SAFETY BULLETIN

Number 004/2017

Product	HI-FOG 1900 Sprinklers installed in A1000 type Assembly Bodies: C-0001318 C-0006553 C40022 C40022.1 C40024 C41041.1 C41041.2 C41042 C41045		
Subject	HI-FOG 1900 may not be compatible with some of the A1000 Assembly Bodies equipped with internal stop valve.		
Summary	The internal stop valve of A1000 Assembly Bodies of the types listed above may be pushed beyond its intended range when a HI-FOG 1900 sprinkler is installed.		
Date	18 th September 2017	Rev.	A

**HI-FOG® 1900 SPRINKLER
WITH
A1000 TYPE ASSEMBLY BODY WITH STOP VALVE
IDENTIFICATION AND CORRECTION PROCEDURE**

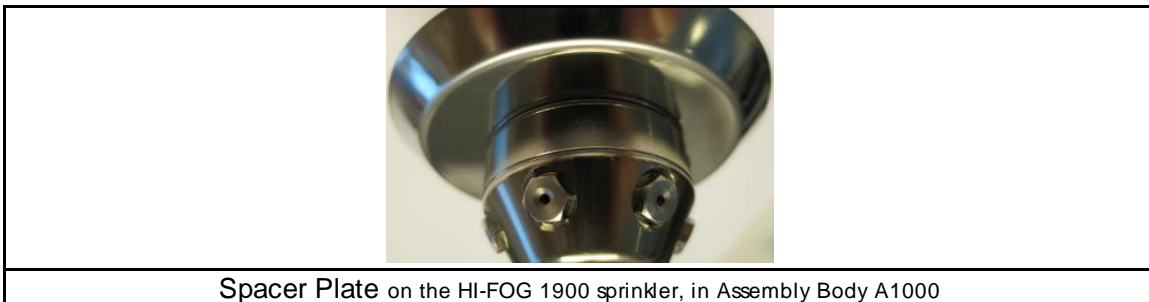
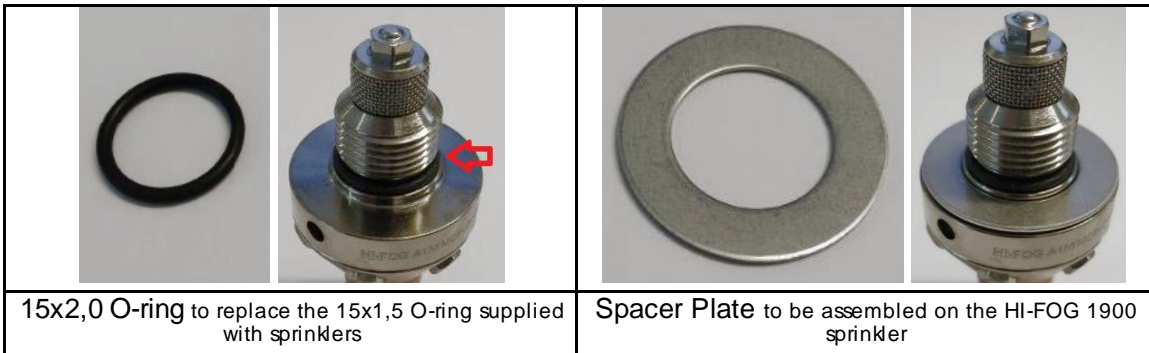
The A1000 Assembly Bodies were built to accommodate the HI-FOG 1000 sprinklers. Some models of this Assembly Body include an internal stop valve that prevents the flow through the Assembly Body if the sprinkler is removed. For these Assembly Body models listed, there is a risk that HI-FOG 1900 sprinkler will press the stop valve beyond the intended range and thus may diminish or in the worst case prevent the water flow to the sprinkler in case of a discharge.

The risk is limited to the Assembly Bodies listed above used in combination with HI-FOG 1900 sprinklers.

The risk does not extend to Assembly Body types A2000, AB and C, to Assembly Bodies without an internal stop valve or to any other HI-FOG sprinklers with any Assembly Body. See illustration below for identification of affected components.

To assure compatibility of HI-FOG 1900 sprinklers with all Assembly Body types, each HI-FOG 1900 sprinkler installed in an affected A1000 type Assembly Body should have the 15x1,5 O-ring replaced with a 15x2,0 O-ring and a Spacer Plate (Marioff Item Code 2000267114) should be installed between the sprinkler and the Assembly Body cover plate. If there is no cover plate, the spacer is to be installed between the sprinkler and the Assembly Body. Follow Marioff instructions (Document number 0003301084) when carrying out the field action.

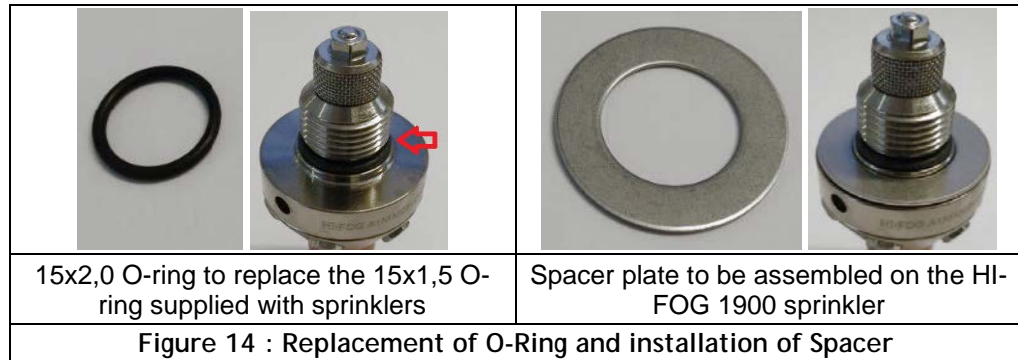
- e. Remove the 15x1,5 O-ring from the sprinkler (see Figure 14). Do not damage or scratch the sprinkler's sealing surface. Cut the removed O-Ring to assure it does not mix with the new seals.

Note: to avoid damage to the sealing surface do not use any metal tools for removing the O-Ring

- f. Install the new 15x2,0 O-ring to the sprinkler by placing the O-ring installation cone (see Figure 05) over the spindle and rolling the new O-ring onto the sprinkler until you are sure the O-ring sits correctly in its groove (see Figure 14).
- g. Install the spacer to the sprinkler (see Figure 14).
